**RE: CONTRACT NO.: 13/WSD/17
DESIGN, BUILD AND OPERATE FIRST STAGE OF TSEUNG KWAN O
DESALINATION PLANT
Submission of Detailed Design Plan for Chlorine and Carbon Dioxide Storage
of Desalination Plant**

Detailed Design Plan for Chlorine and Carbon Dioxide Storage of Desalination Plant

Contract No. 13/WSD/17 Design, Build and Operate First Stage of Tseung Kwan O Desalination Plant

Submission No.	TKOD1-RPT-A000-JGN0003-04		
Subject	Submission of Detailed Design Plan for Chlorine and Carbon Dioxide Storage of Desalination Plant	Date	9/07/2021
Version	04	Page	1 of 2

©COPYRIGHT RESERVED

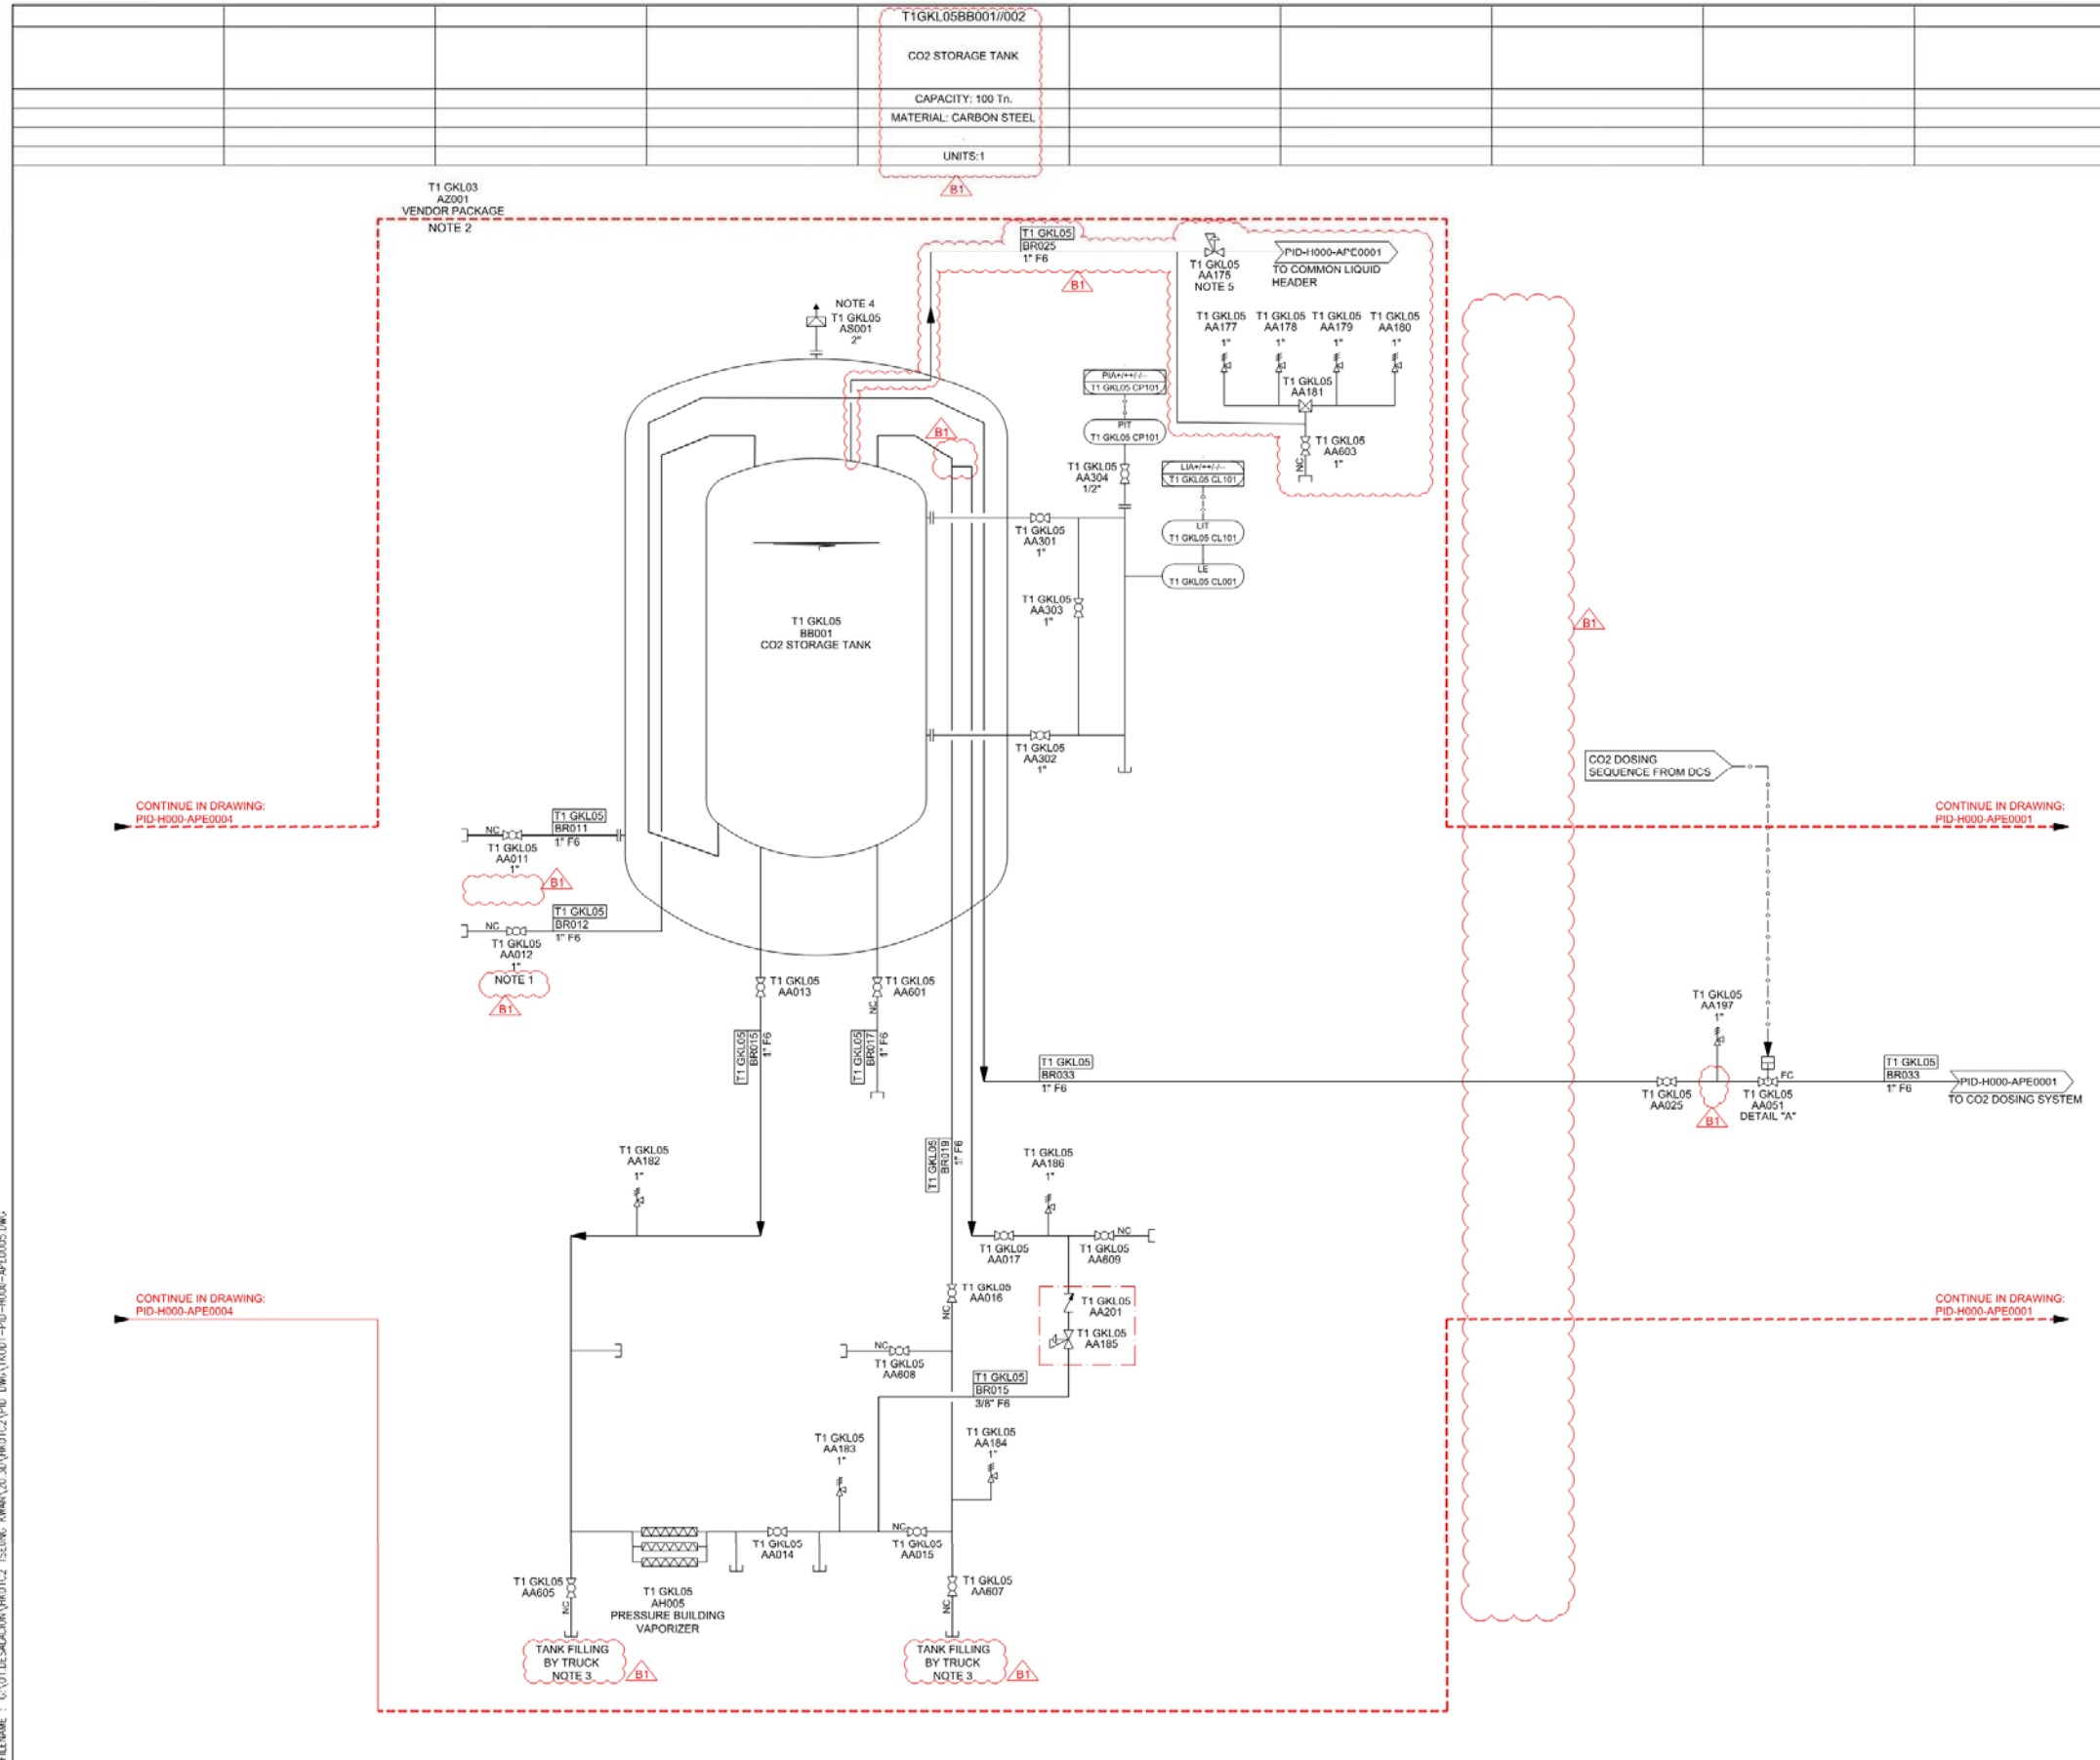
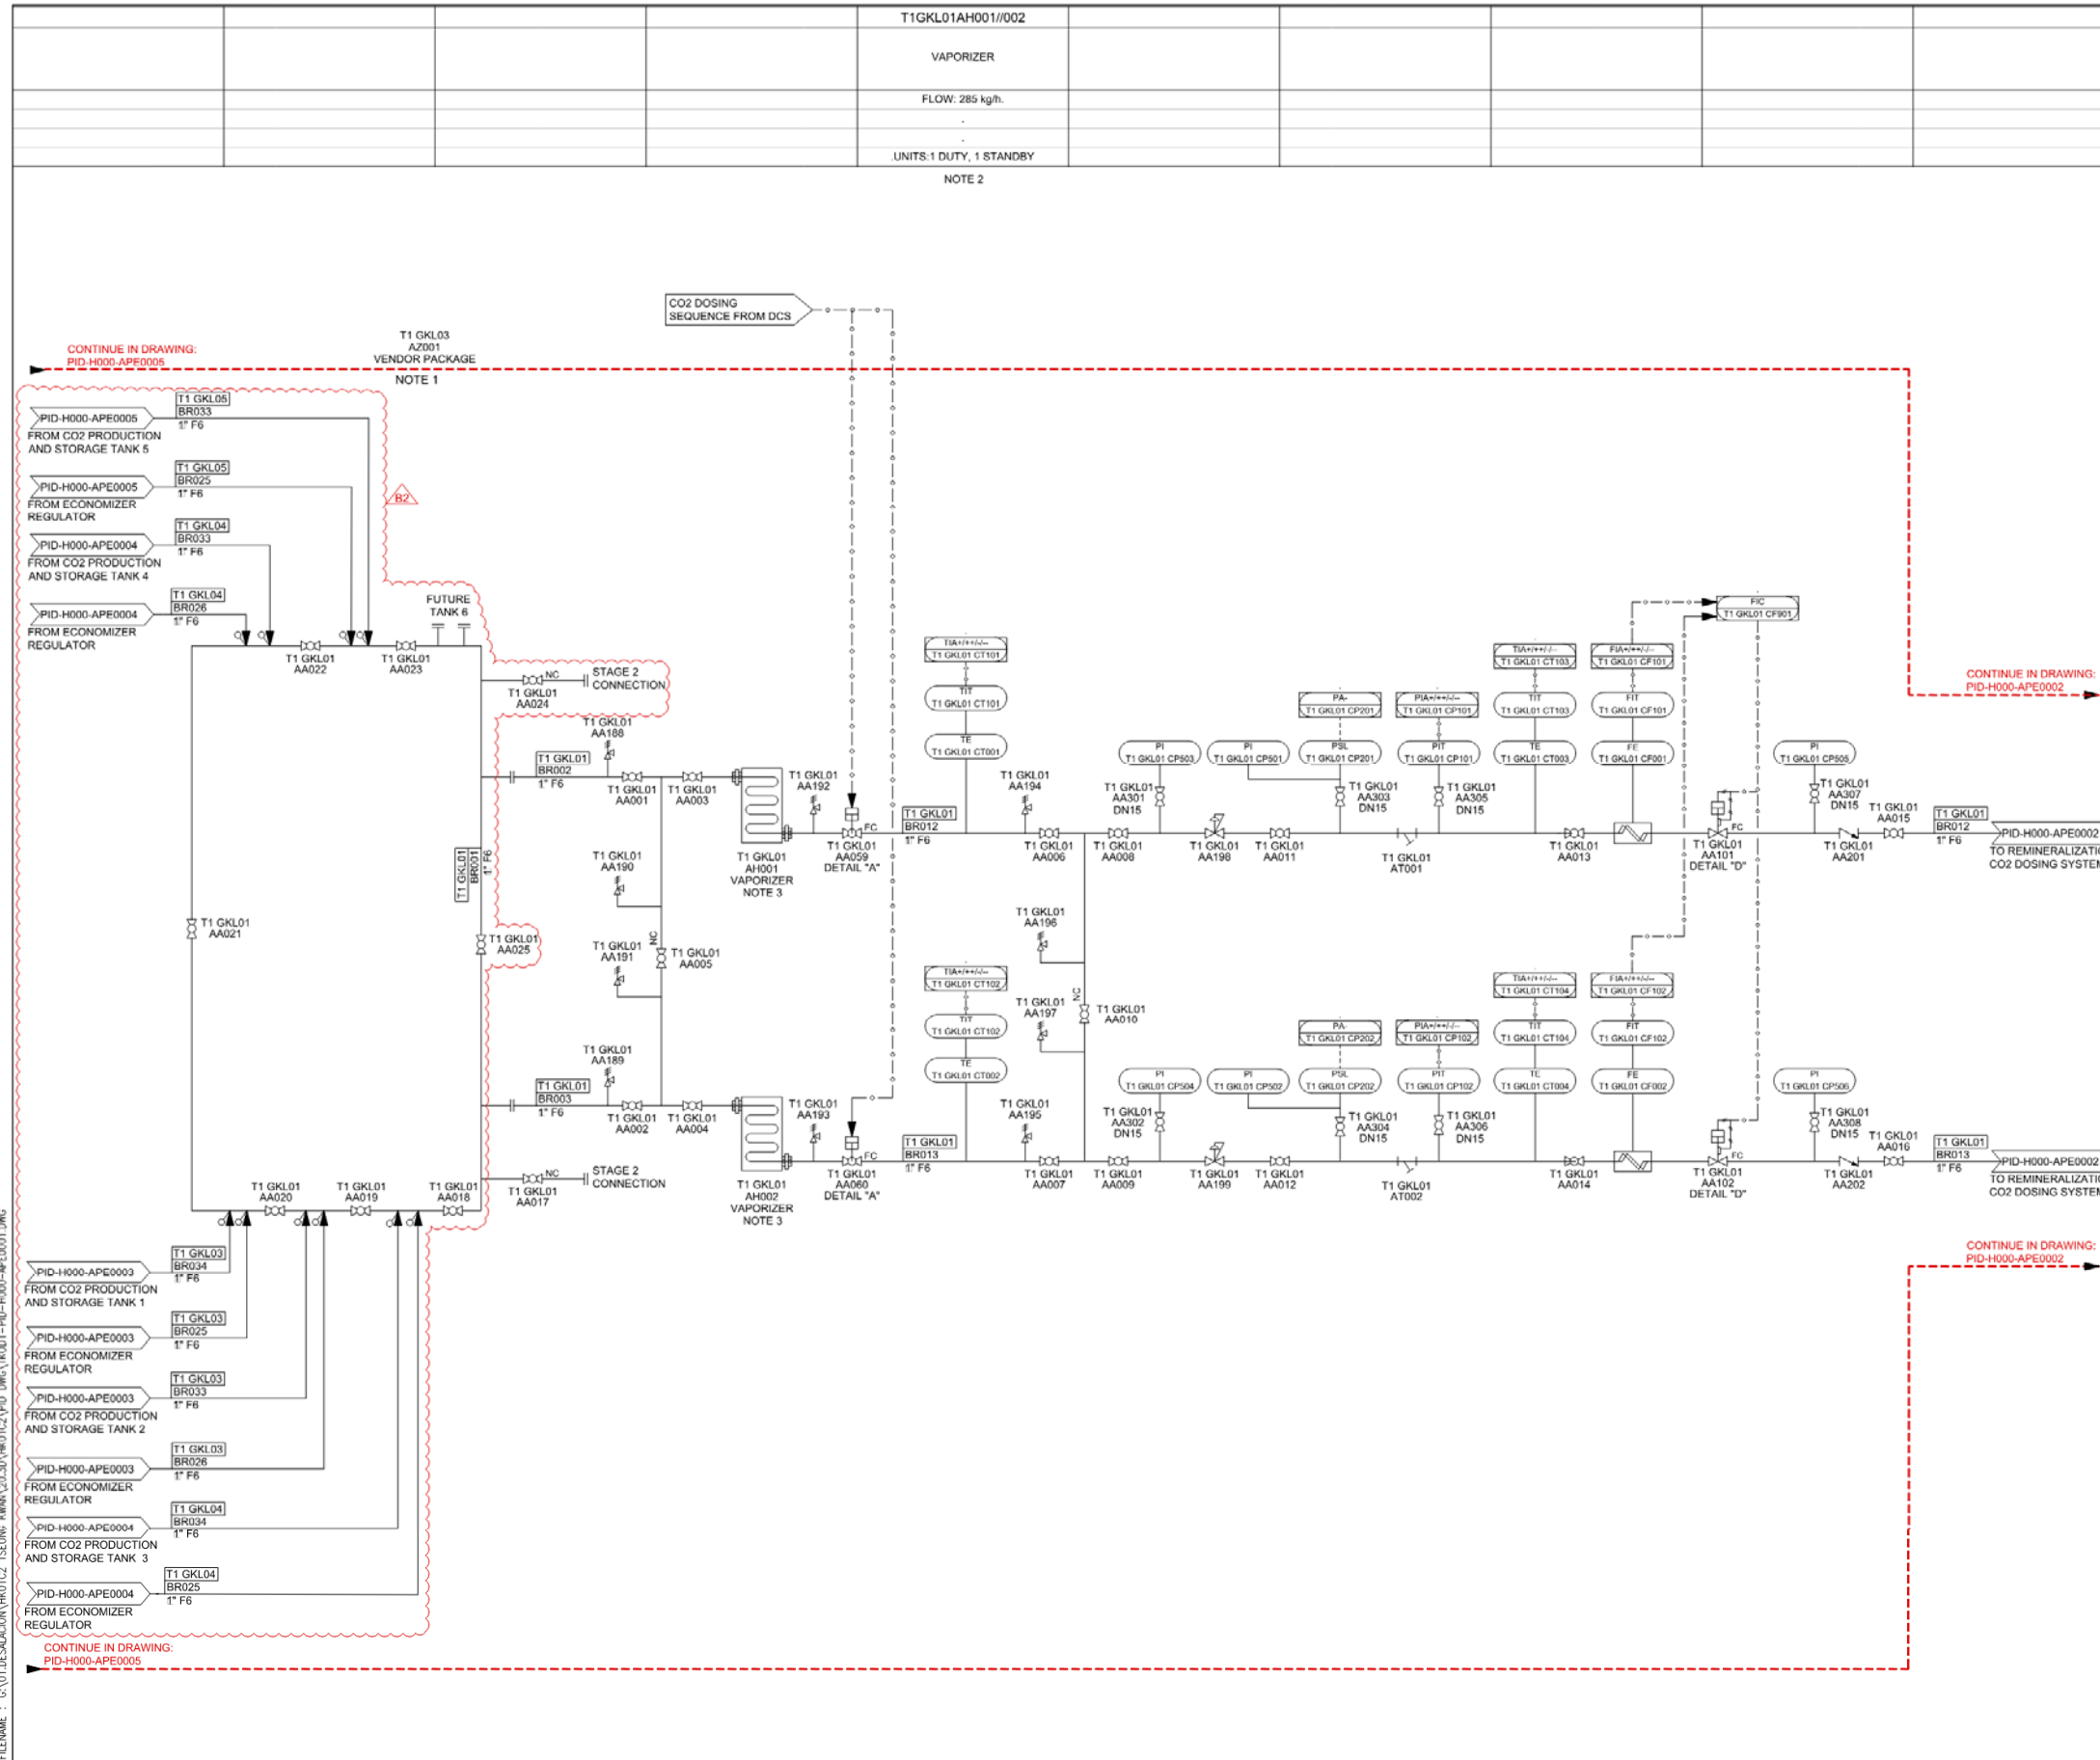
2. Appendix B Please explain how the design of the pressure relief valves system can avoid common mode failure.	Explanation has been added in Appendix B-5 of the revised plan. The P&IDs in Appendix B-2 have also been revised.
